## Department of Transportation

Subject: WisDOT Interstate Study Staff Review

Date: July 5, 2023

### Alternative 1 Summary of Impacts

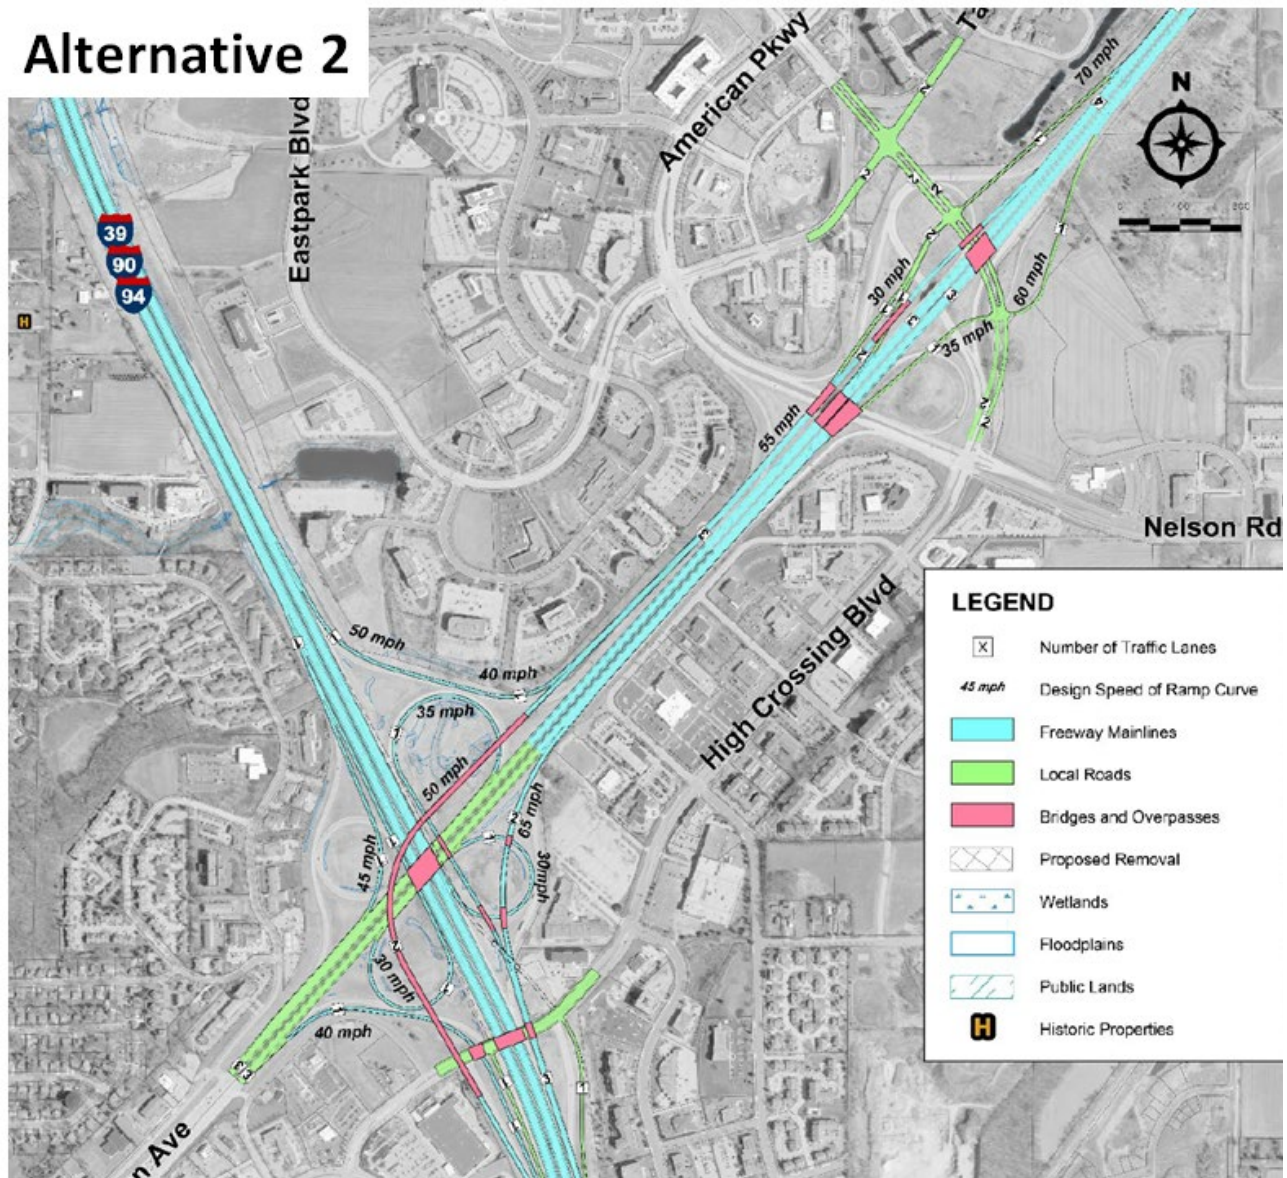
1. The signals on the East Washington Ramp terminals would help introduce an urban roadway with slower speeds.
2. There is no urban street connection to the American center with this alternative. Access without a motor vehicle remains difficult.
3. There is one elevated freeflow ramp, which could increase noise impacts.
4. This alternative would not influence density or development opportunities.
5. This alternative would not enhance BRT routing to the American Center.
6. This alternative relocates the US 151 entrance of the American Center from American Parkway to American Family Drive, yet maintains the Nelson Road/American Pkwy entrance from High Crossing Blvd.

### Alternative 2 Summary of Impacts

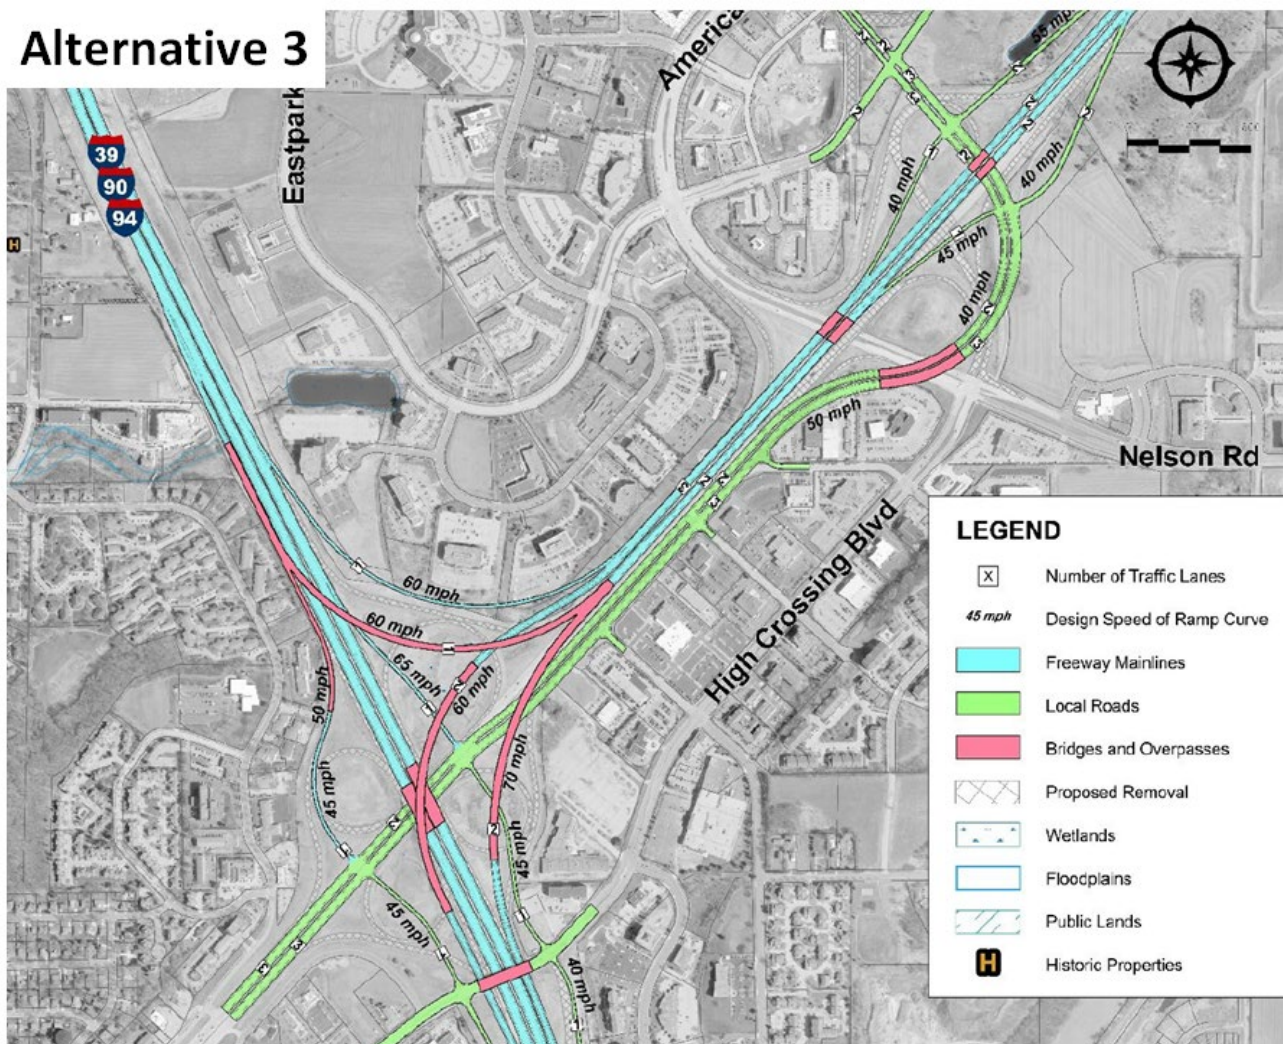
1. The cloverleaf ramps remain, and East Washington speeds would remain high.
2. There is no urban street connection to the American Center with this alternative. Access without a motor vehicle remains difficult.
3. There is one elevated freeflow ramp, which could increase noise impacts.
4. This alternative would not influence density or development opportunities.
5. This alternative would not enhance BRT routing to the American Center.
6. This alternative relocates the US 151 entrance of the American Center from American Parkway to American Family Drive, yet maintains the Nelson Road/American Pkwy entrance from High Crossing Blvd.

### Alternative 3 Summary of Impacts

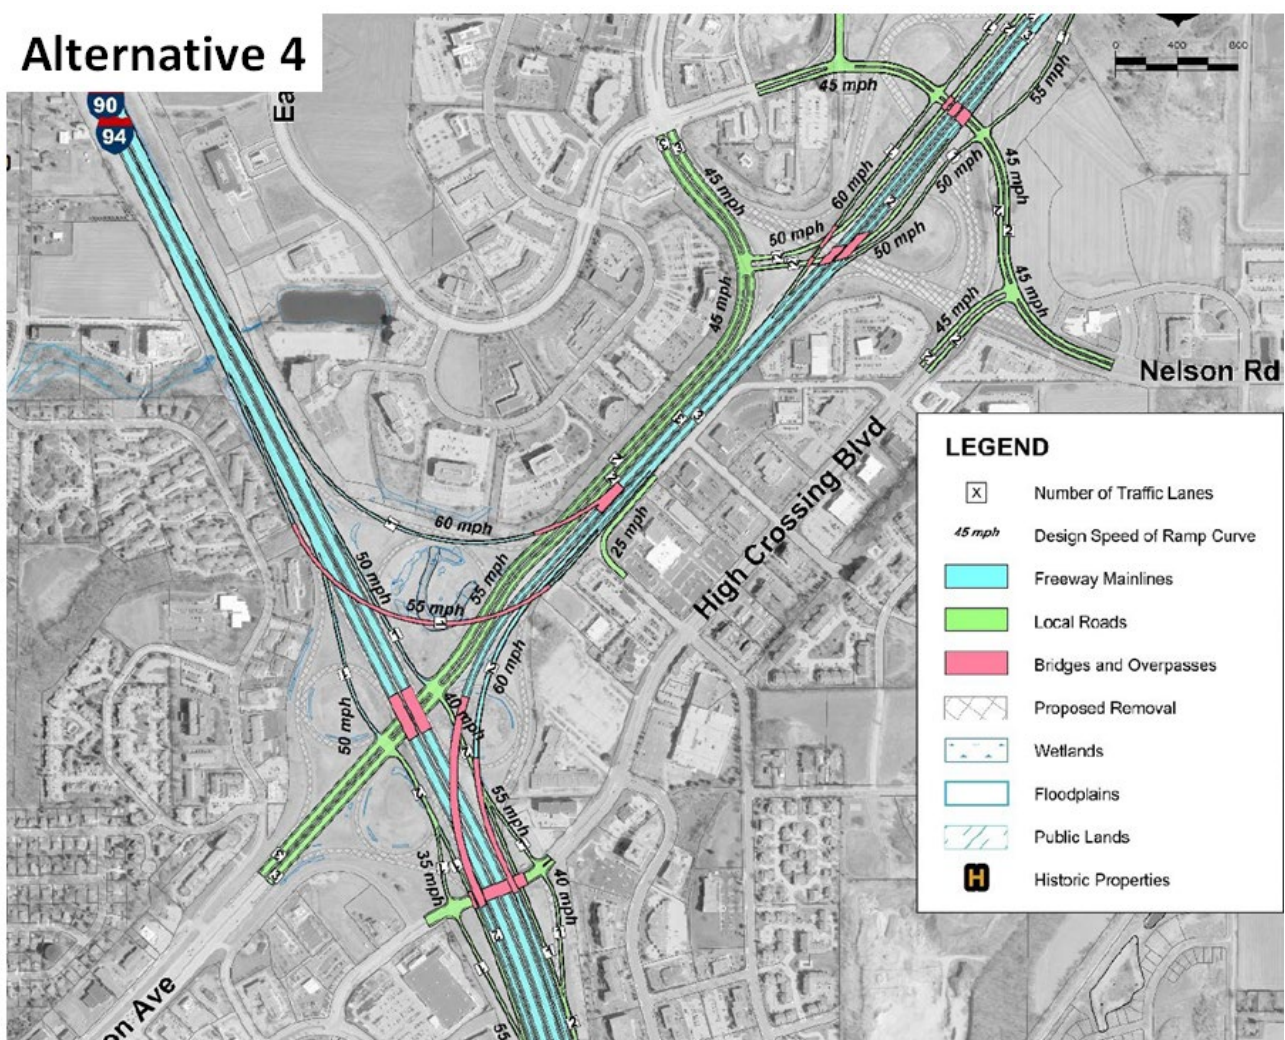
1. The signals on the East Washington Ramp terminals would help introduce an urban roadway with slower speeds. Additionally, the extension of East Washington Ave as an urban street with intersections would help to slow travel speeds east of the Interstate.

2. There is an urban street connection to the American Center with this alternative, which provides direct access for cyclists, pedestrians, and auto users who do not want use the freeway. This helps connect the American Center with the rest of the city. The urban street runs adjacent to the freeway, which could be less comfortable for some users.

3. There are three elevated freeflow ramps, which would increase noise impacts.
4. This alternative could enhance density or development opportunities. The extension of East Washington Ave along Wayne Terrace provides better access and visibility to the High Crossing area. This could create higher and better (denser) uses for the properties between Wayne Terrace and High Crossing.

5. This alternative probably would not affect BRT routing to the American Center. BRT probably would continue on High Crossing to serve the residential areas south.

6. This alternative relocates the US 151 main entrance of the American Center from American Parkway to American Family Drive through a diamond interchange. Access to American Parkway is maintained through High Crossing Blvd.

### Alternative 4 Summary of Impacts

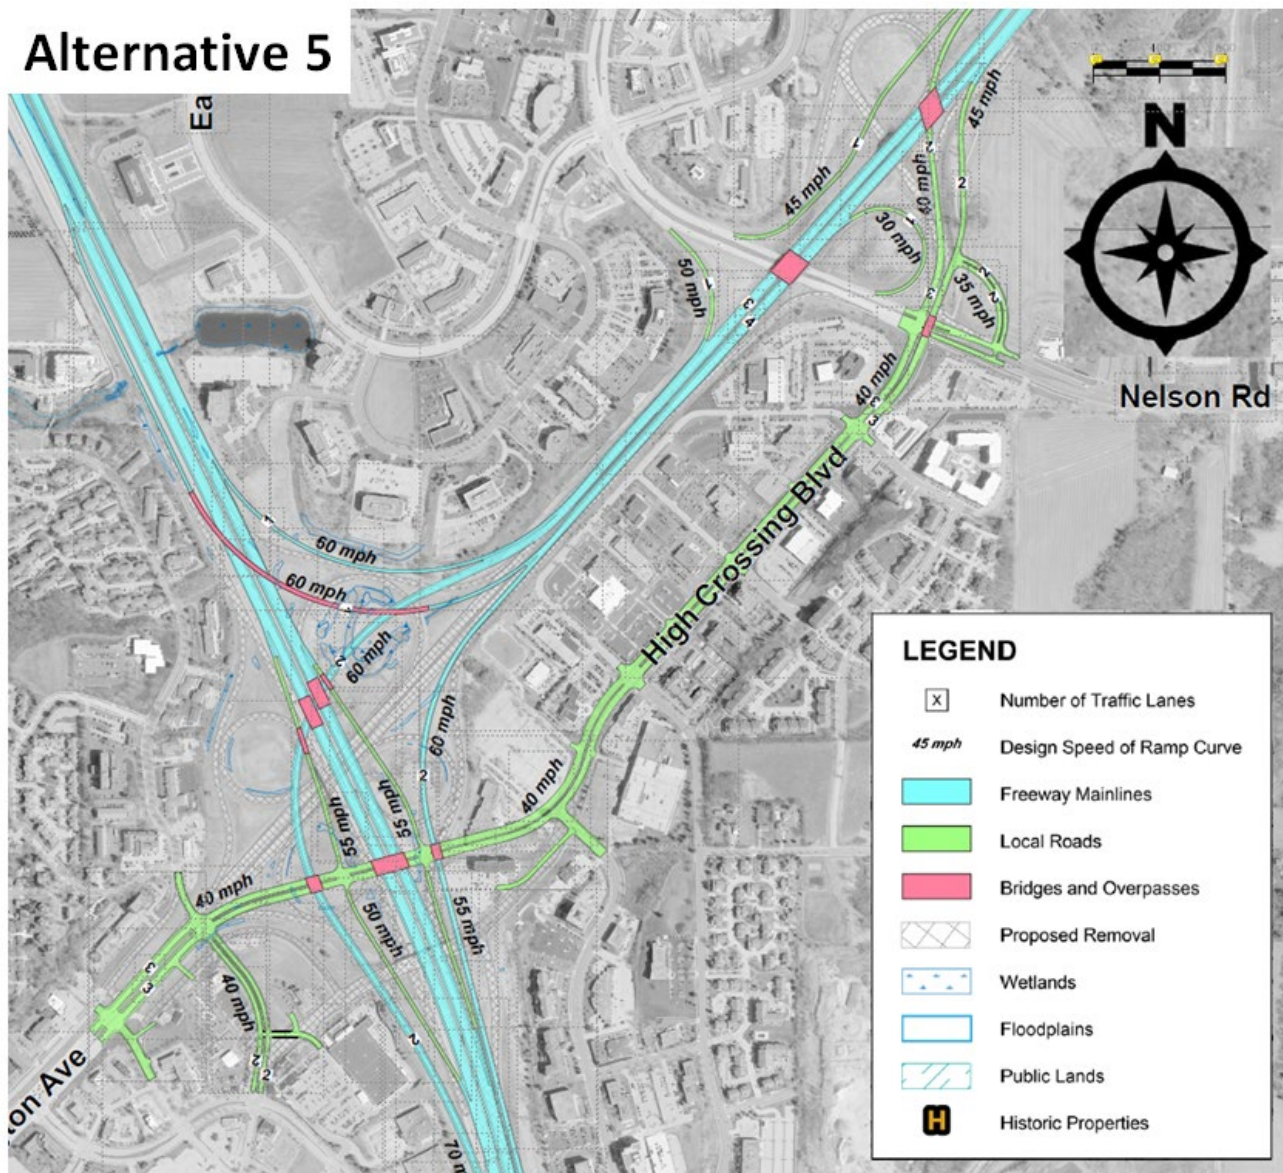
1. The signals on the East Washington Ramp terminals would help introduce an urban roadway with slower speeds. However, the East Washington Ave extension would not provide as much speed moderation because there are no intersections or property accesses. This section of roadway would encourage higher than normal travel speeds.

2. The urban street connection to the American Center provides direct access for cyclists, pedestrians, and drivers who do not want use the freeway. Speeds on the East Washington Ave extension are a concern.

3. There are three elevated freeflow ramps, which would increase noise impacts.
4. This alternative would not enhance density or development opportunities. There is no property access or street intersections off of the extension, therefore the street would serve mainly as a local connection.

7. This alternative probably would have no effect on BRT routing to the American Center. BRT probably would continue on High Crossing to serve the residential areas south.

8. This alternative creates an addition US 151 entrance to the American Center through a modified diamond interchange connection of Nelson Road with Eastpark Blvd. It also provides an option for US 151 travelers to connect directly with the American Parkway/East Washington Ave extension.

#### **Alternative 5 Summary of Impacts**

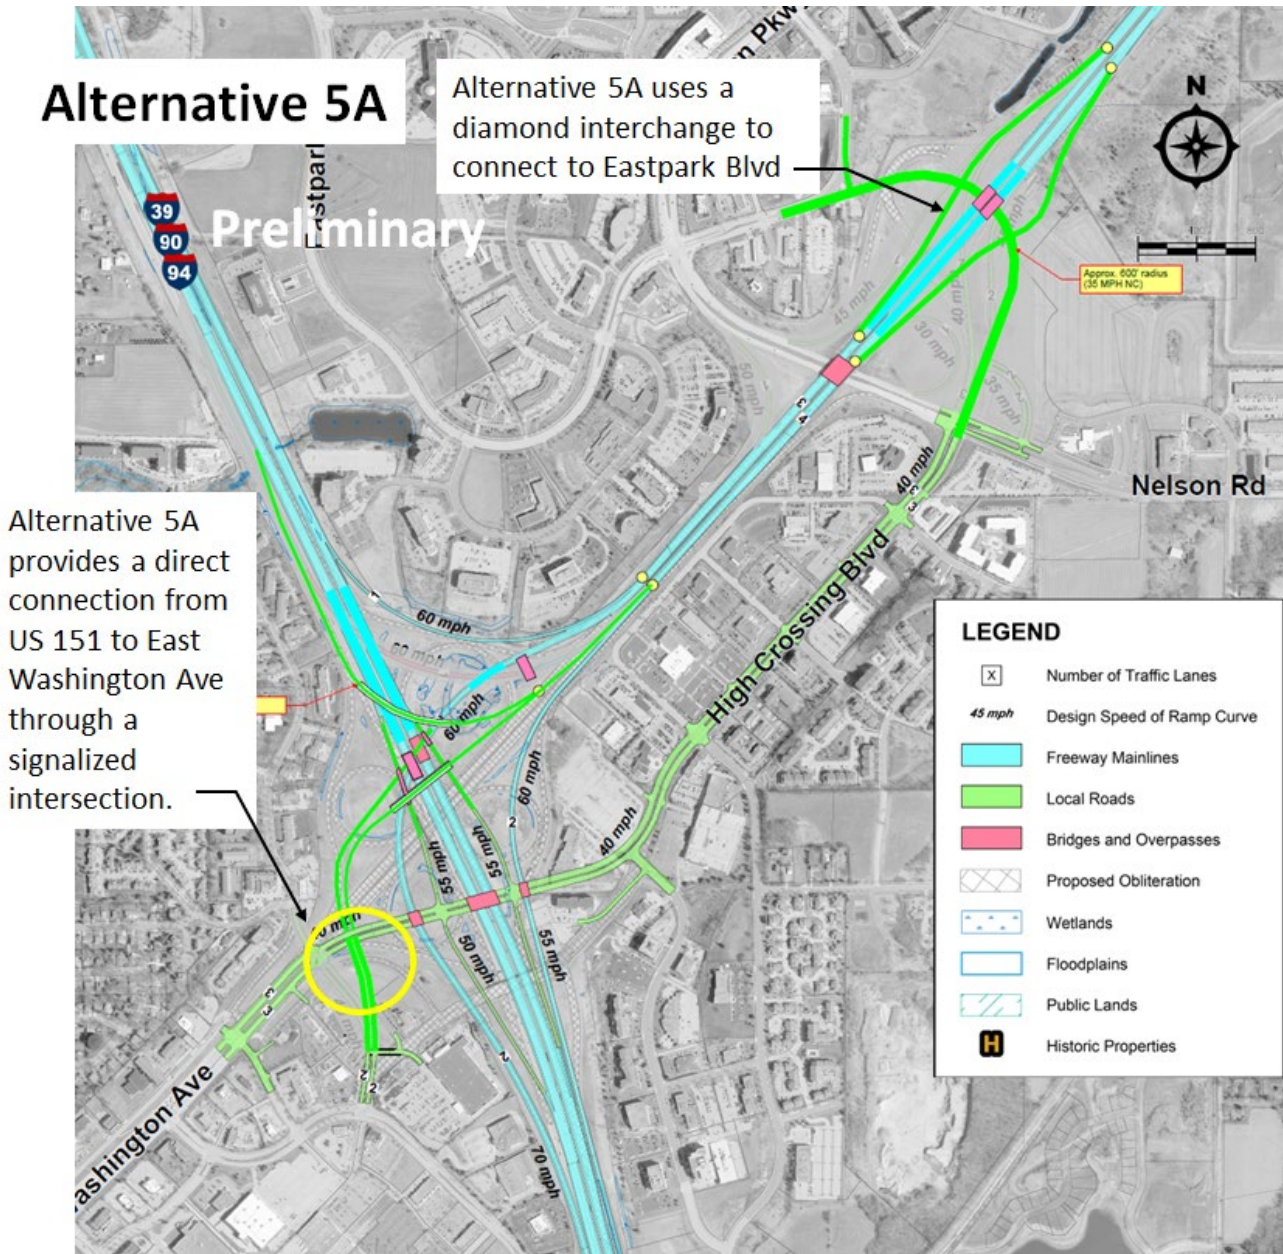
1. The signals on the East Washington Ramp terminals would help introduce an urban roadway with slower speeds. Additionally, East Washington Ave as an urban street with intersections is extended northeast to Nelson Road/American Family Drive. The use of High Crossing Blvd as an urban street would also help to slow travel speeds, introducing city speeds a full mile east of the Interstate.

2. The urban street connection to the American Center provides direct access for cyclists, pedestrians, and drivers who do not want use the freeway, better connecting the American Center with the rest of the city.

3. There is only one elevated freeflow ramp, and two depressed freeflow ramps. The elevated ramp would increase noise levels, however the two depressed ramps would have lower noise impacts than Alternatives 3 and 4.

4. This alternative would enhance density or development opportunities. High Crossing Blvd is underutilized and has high redevelopment potential. The extension of East Washington Ave onto High Crossing Blvd would provide better access and visibility.

5. This alternative would enhance BRT routing to the American Center. Combining East Washington with High Crossing Blvd eliminates turns and provide a more direct connection to both the American Center and the Sun Prairie Park and Ride.

6. This alternative maintains the current main entrance of the American Center from American Parkway to American Family Drive through a jug handle similar to the current access. An additional access into the American Center is not provided.

Note: WisDOT is proposing expanding High Crossing Blvd. to three lanes in each direction with this alternative. With High Crossing Blvd. currently seeing approximately 15,000-18,000 average weekday traffic, which is low for a road of its size, Staff has encouraged WisDOT to examine traffic projections to see if this alternative requires an expansion of High Crossing Blvd. Similarly, staff has requested further information from WisDOT as to whether the jug handle shown at Nelson Road is needed.
